SITE DEVELOPMENT FILE DA.07.022
JANE-RUTH DEVELOPMENT INC.

1. THAT Site Development File DA.07.022 (Jane-Ruth Development Inc.) BE APPROVED, to permit a 16-storey, 225 unit residential condominium building, as shown on Attachment #3, subject to the following conditions:

Building 'C' Site Plan

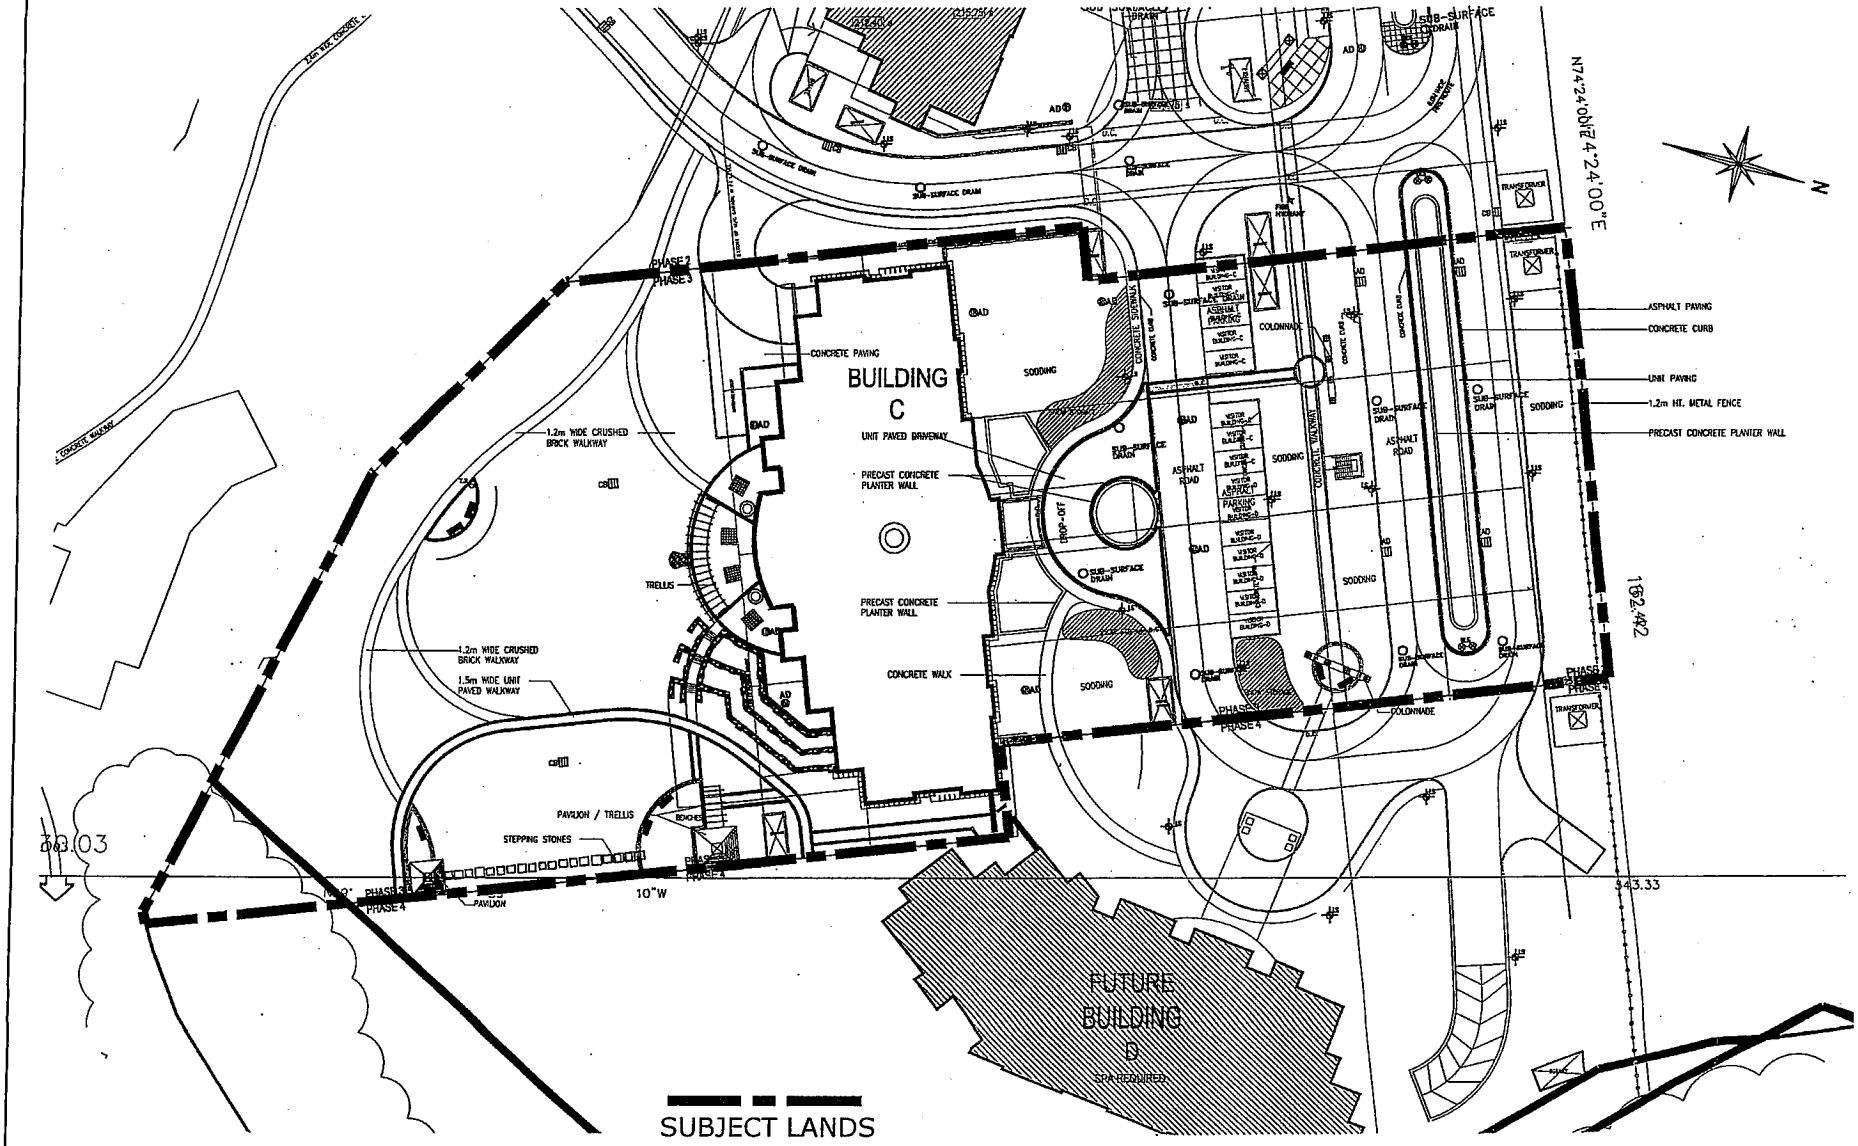
It has been determined that an additional variance is required to increase the maximum building height to 55 m, whereas, the By-law currently permits a maximum building height of 50 m. The Owner is required to amend the Minor Variance Application (File A109/07) and the application is required to be approved by Vaughan Committee of Adjustment and be final and binding, prior to the registration of the implementing site plan agreement.

The Owner has submitted a context plan as shown on Attachment #2 for the overall Jane-Ruth Development Inc. land holdings. The detailed site plan for Building "C" is shown on Attachment #3. The context plan shows four, 16-storey residential buildings organized around an internal access road, which runs from Rutherford Road and across the valley to a new east/west driveway from Jane Street. An electronic gate and a gatehouse are located at the ends of the internal road to control access and egress from the site. Building "A" is located at the corner of Jane Street and Rutherford Road and is separated from Buildings "B", "C" and "D" by the valley lands, which diagonally traverses the site. Building "B" will be the only other building that fronts onto Jane Street. The site will be developed as a condominium project and therefore, snow removal and garbage pick-up will be privately contracted.

The current site plan application will facilitate the development of Building "C" only. Building "C" is located within the interior of the overall site and between Buildings "B" and "D". The internal driveway separates Buildings "B" and "C". A roundabout, which is tied in with the roundabout for Building "D", is located in front of the main entry of the building to provide a convenient drop-off area for residents and visitors. A total of 15 grade level visitor parking spaces are provided opposite the main entrance of Building "C" of which, 8 spaces are allocated to Building "C" and 7 spaces are allocated to Building "D". Otherwise, all of the parking for Building "C" is located in an underground garage accessed via a driveway from the main internal road. The garbage pick-up area is located on the south west side of Building "C".

iii) that Committee of Adjustment Minor Variance Application File A109/07 be revised to provide for a minimum of 312 parking spaces and a maximum building height of 55 m and that the Application be approved and the Committee's decision be final and binding;

Master Landscape Plan

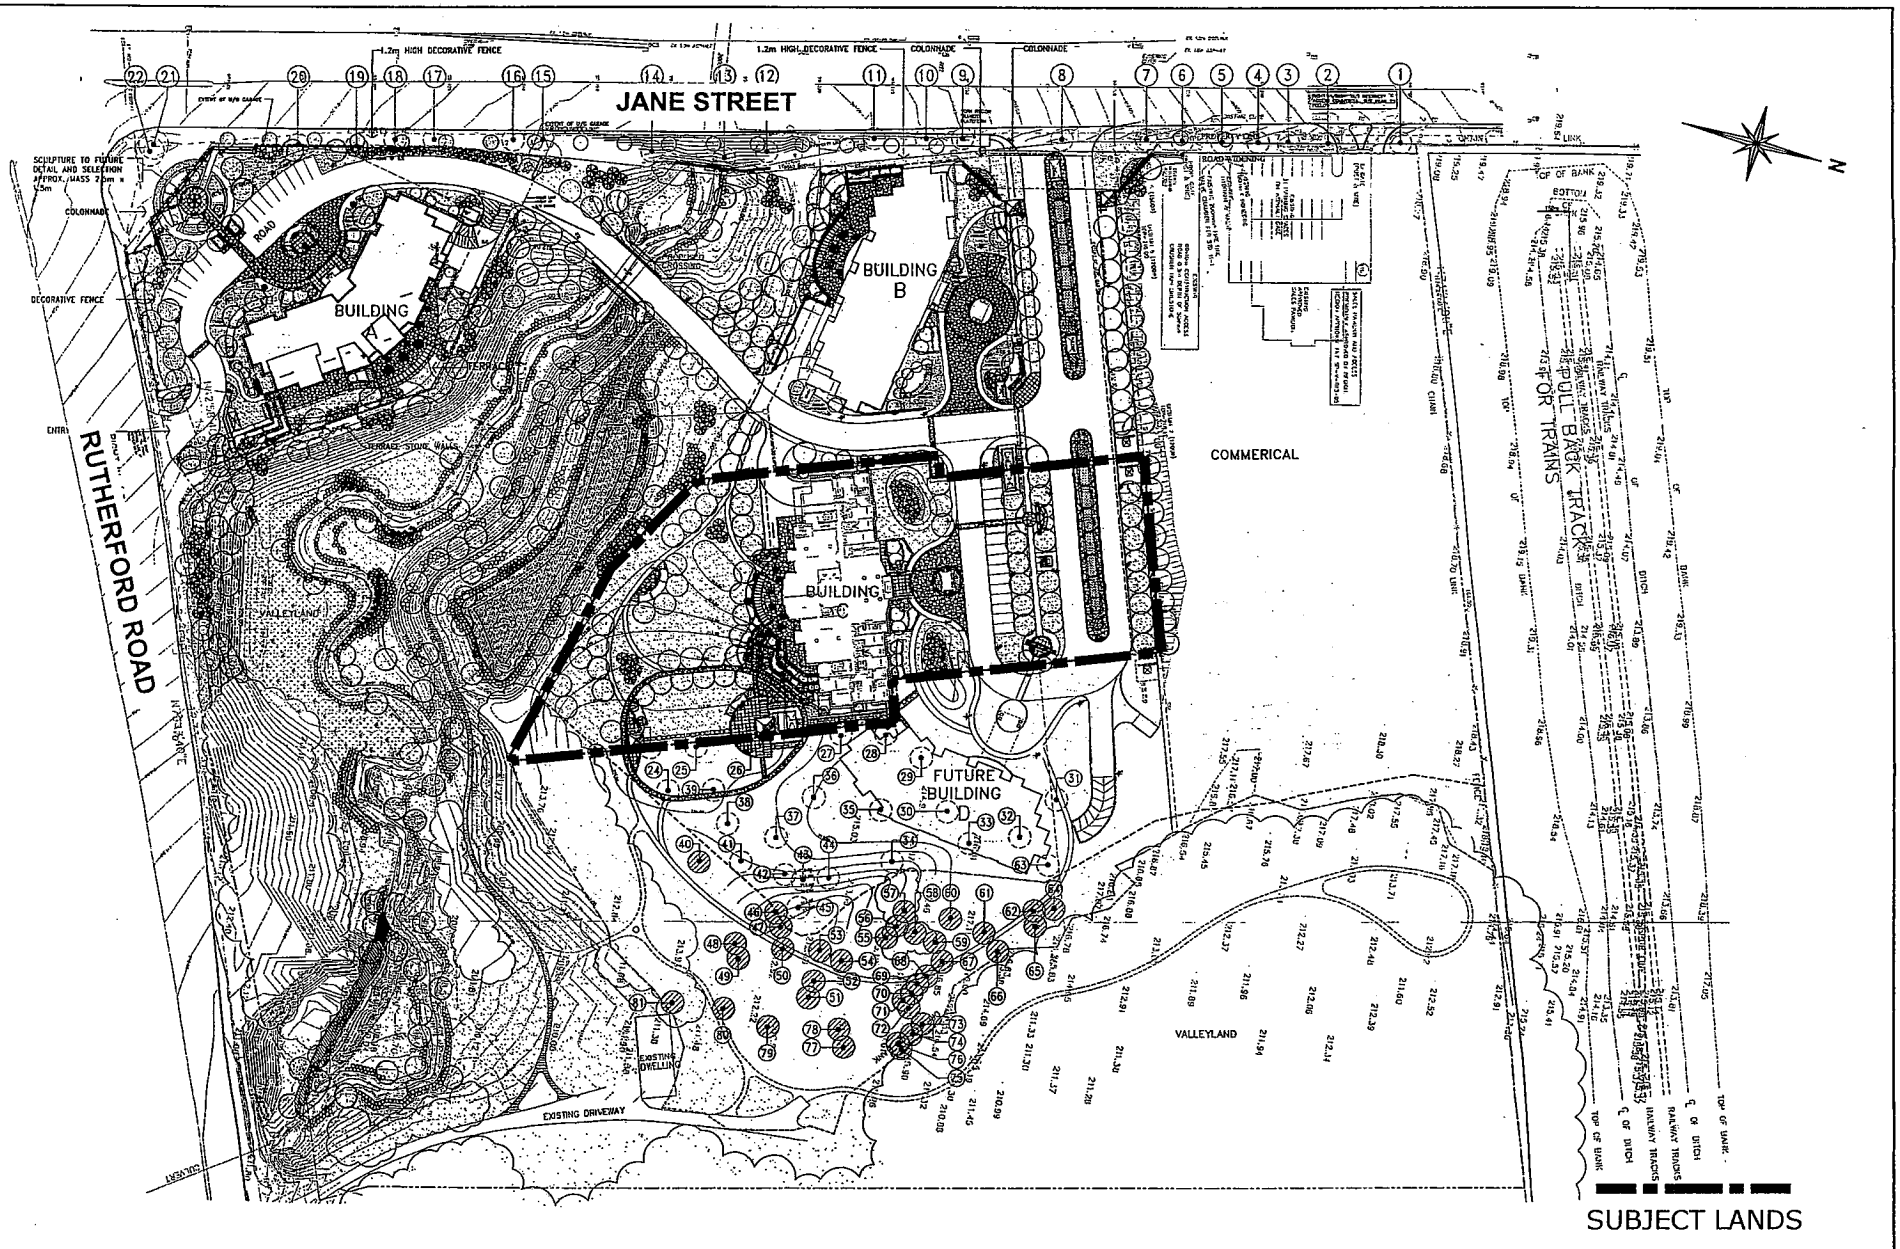
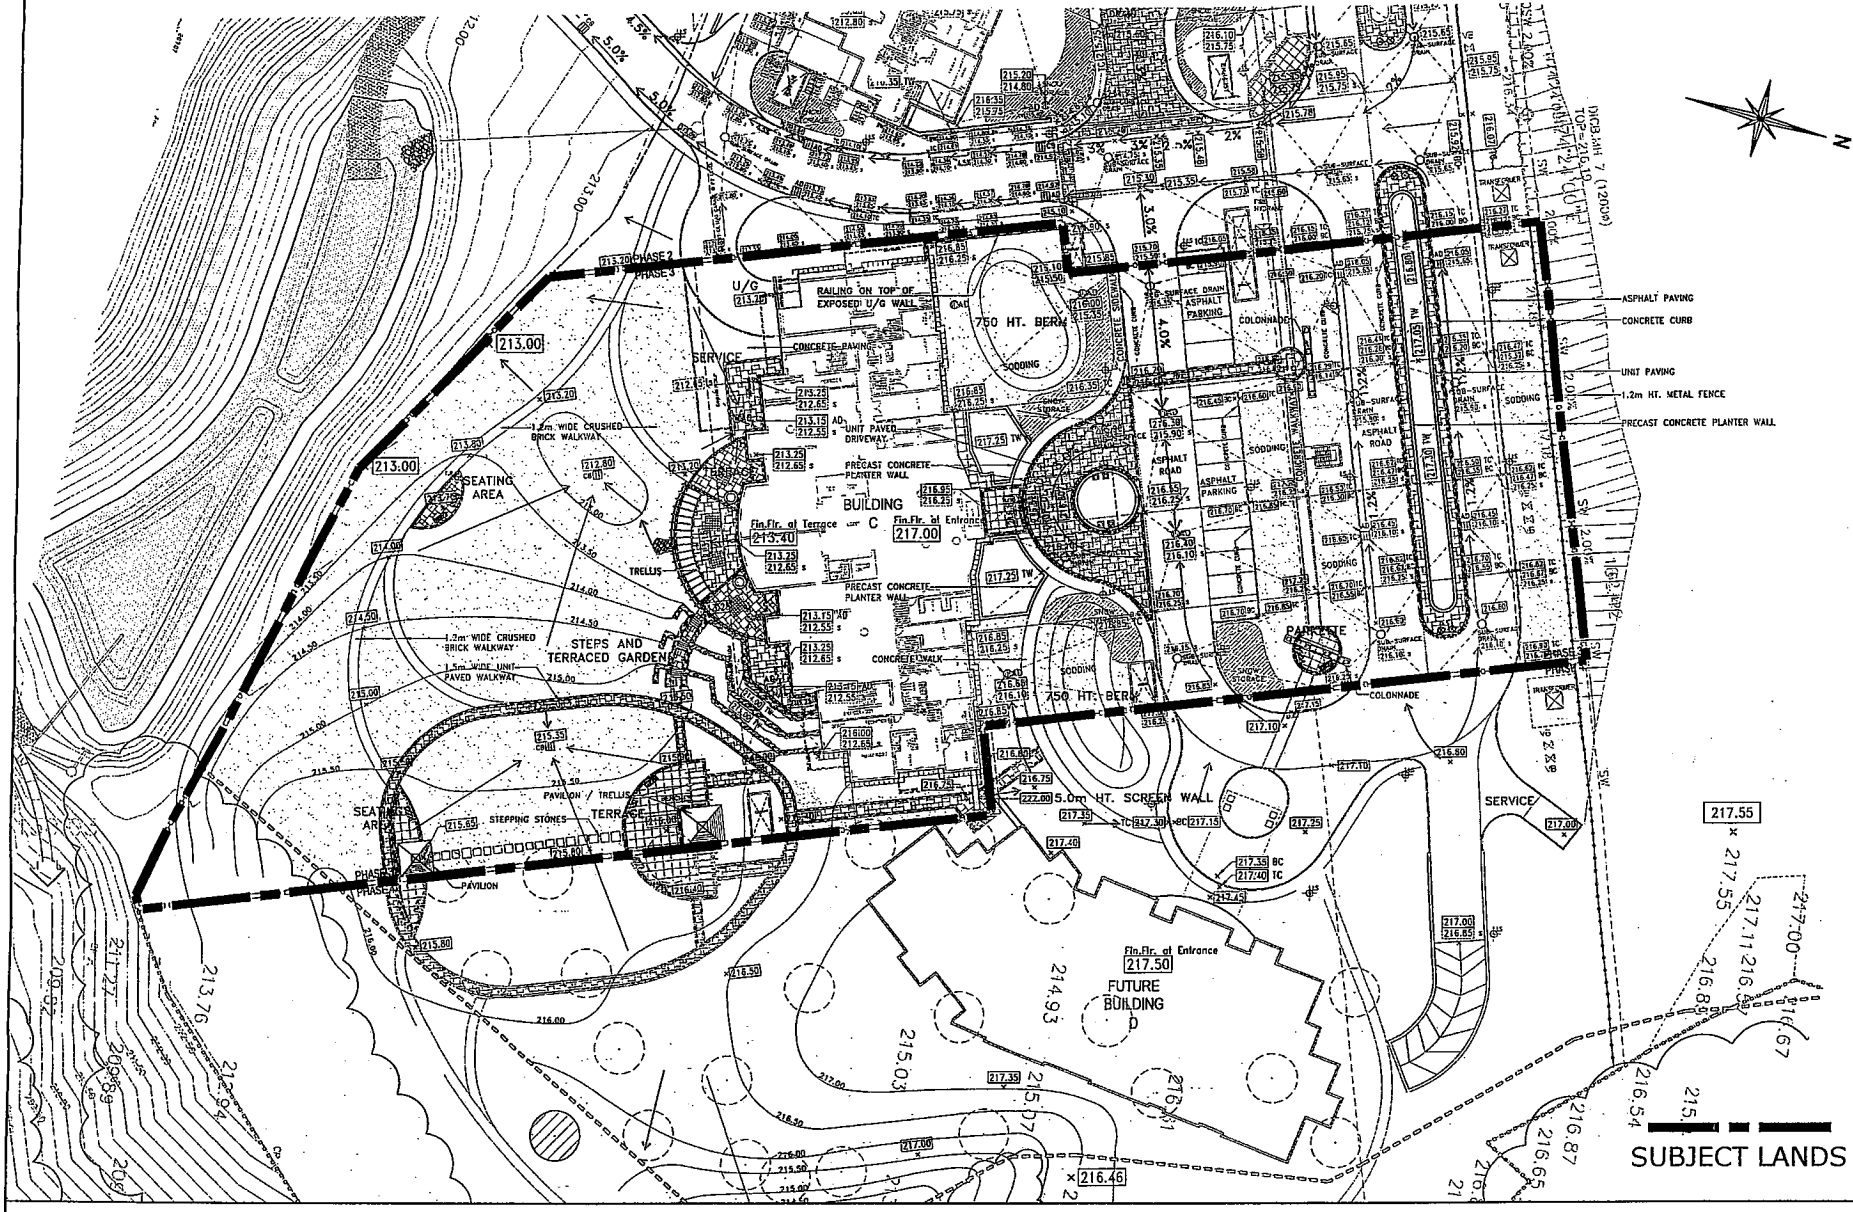
The Development Planning Department has reviewed the landscape plans and is generally satisfied with the proposed landscaping provided that the planting species is further diversified with minimum 60 cm caliper for all trees and a minimum 60cm height and spread for shrubs. Furthermore, all metal proposed in the landscaping is to be aluminum for weather-resistance and electrostatically powder-coated for superior paint adhesion. The Owner has been advised that the landscape cost estimate shall also be revised to reflect current market replacement costs.

The Toronto and Region Conservation Authority has reviewed the site development application and has no objections to the approval of the proposed development. TRCA, however, notes that additional information is required from the Owner indicating the amount and duration, including monitoring of the dewatering that is expected. Additionally, an analysis should be completed detailing any expected impacts the dewatering will have on the surrounding natural features, including the watercourse. Furthermore, silt fencing and tree protection fencing should be clearly delineated on the plan. TRCA requests that no stock piling of materials is to occur adjacent to or near the natural features. TRCA requires that the landscape plan be modified to remove the

invasive planting material, in particular the *acer pantanoides* and replace it with a non-invasive tree and the *thuja occidentalis* (emerald) should be replaced with a native *thuja occidentalis*.

Building 'C' - South & West Elevations

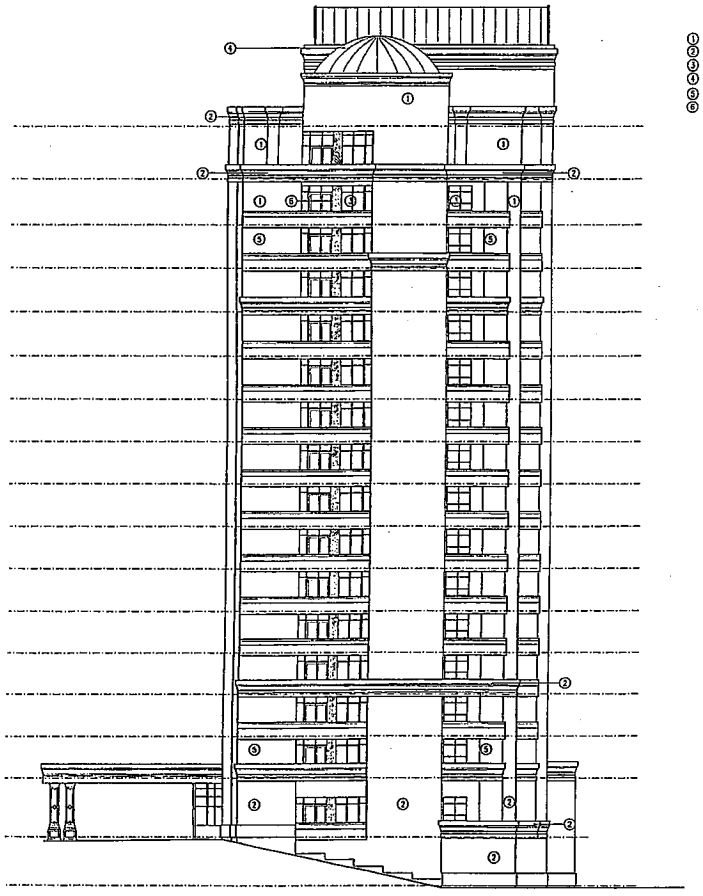
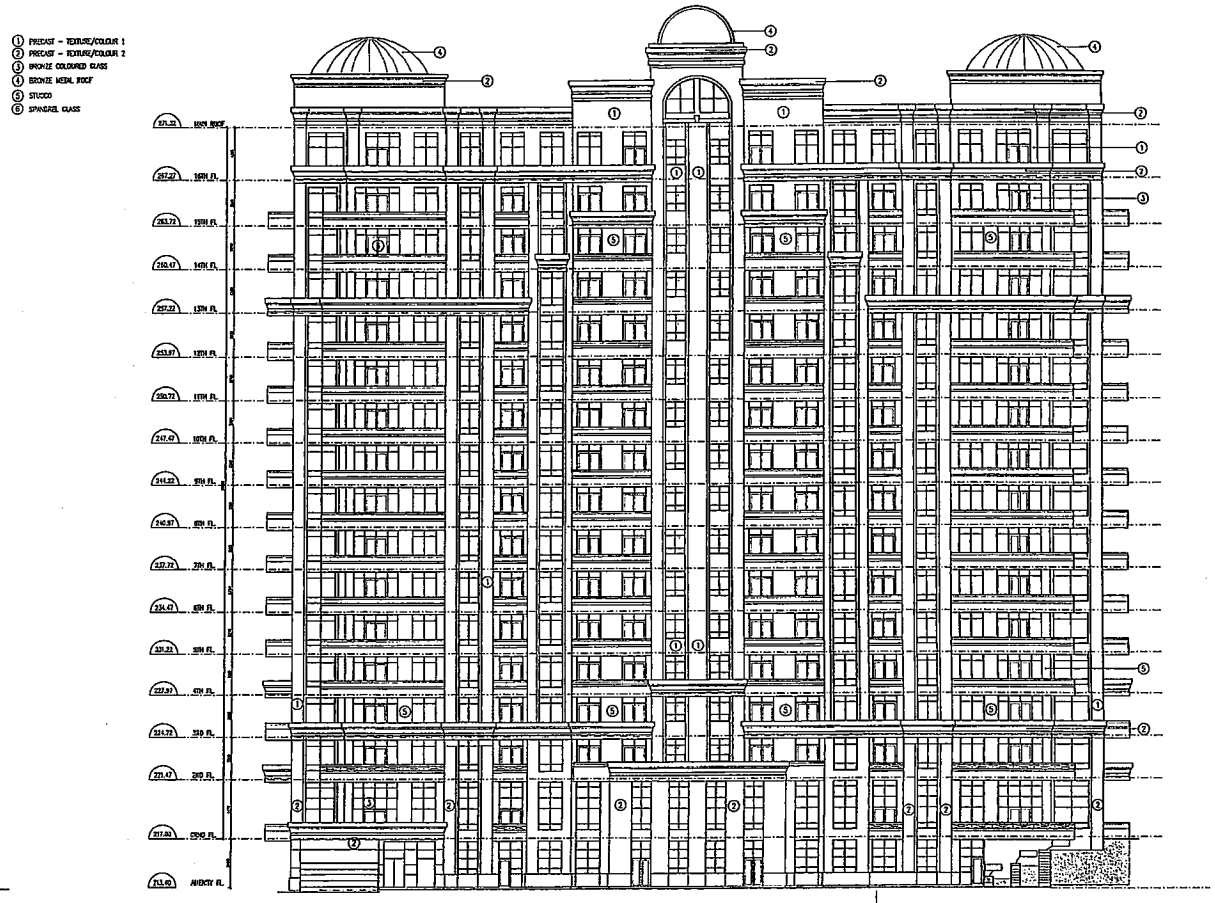
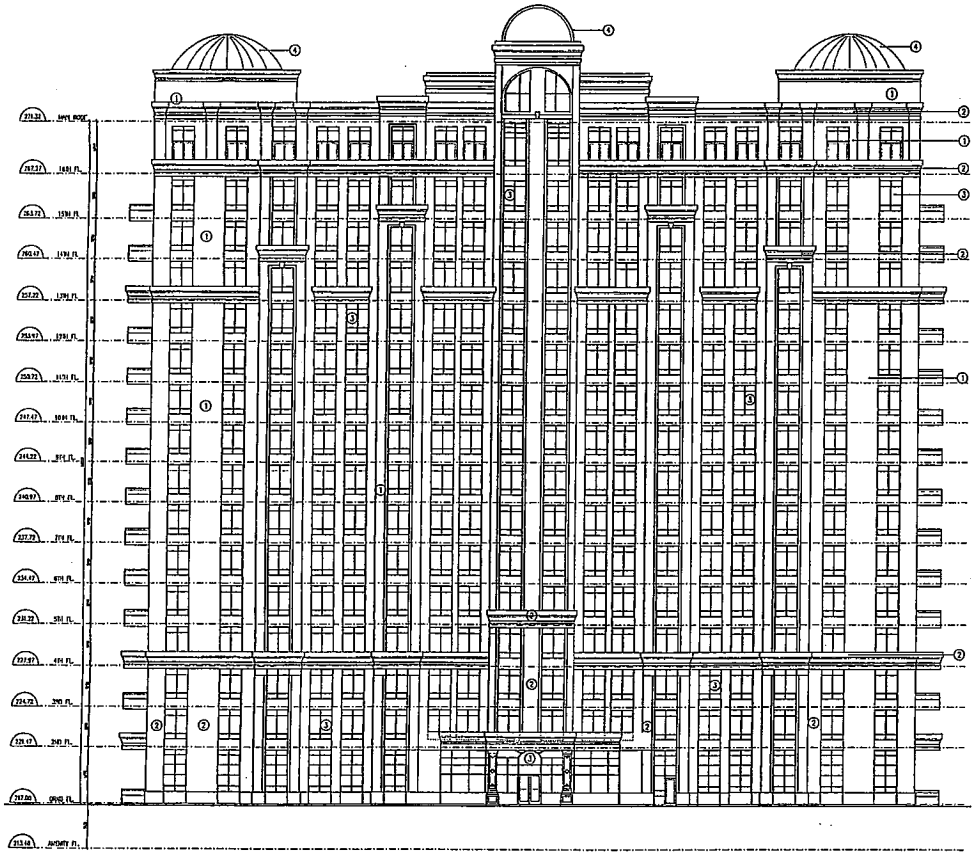
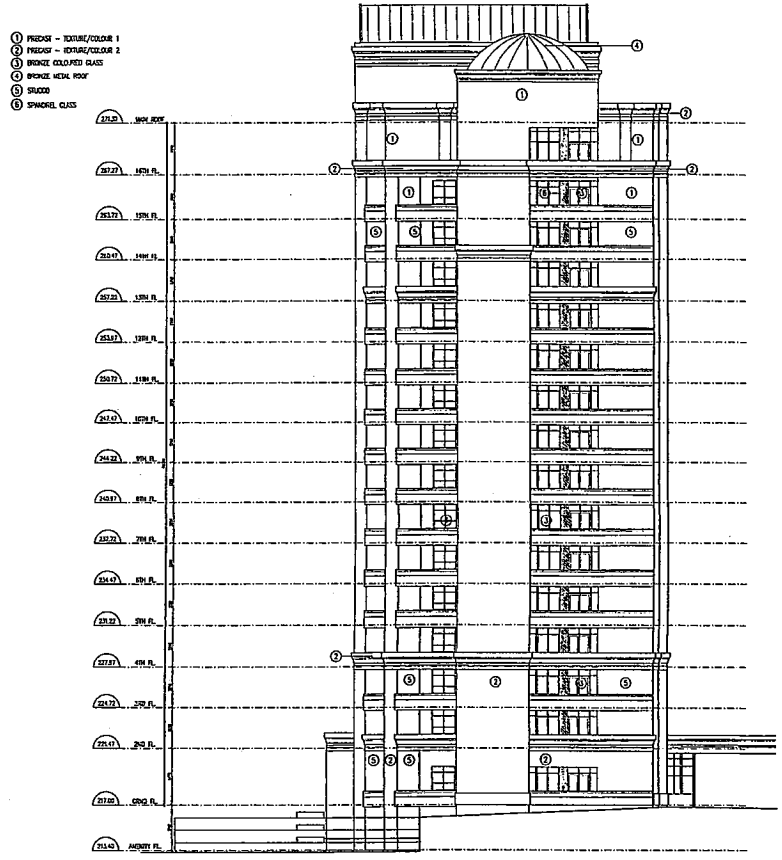
The elevations for Building "C" are similar to the approved Buildings "A" and "B" currently under construction in terms of their appearance and materials and are shown on Attachments #6 and #7. The building height is 16 storeys and 55.0 metres in height. The main entry to the building is composed of a double door surrounded by glass panels and framed with a precast concrete element. The primary building material is precast concrete panels utilizing two different colours and textures to provide visual interest to the building. The base of the building including the first three floors will be clad in a darker taupe coloured, exposed aggregate textured precast cladding. An architectural precast cornice molding is utilized as a transition feature to the upper storeys, which are finished in a smooth precast concrete panel with a lighter shade of the base colour. The architectural precast cornice molding is repeated at the upper levels and top of each building.

A bronze coloured glass will be used for all of the windows and three bronze metal domes are proposed at the roof level. Balconies are located on the north and south elevations of the building.

The final elevation plans must be approved to the satisfaction of the Development Planning Department.
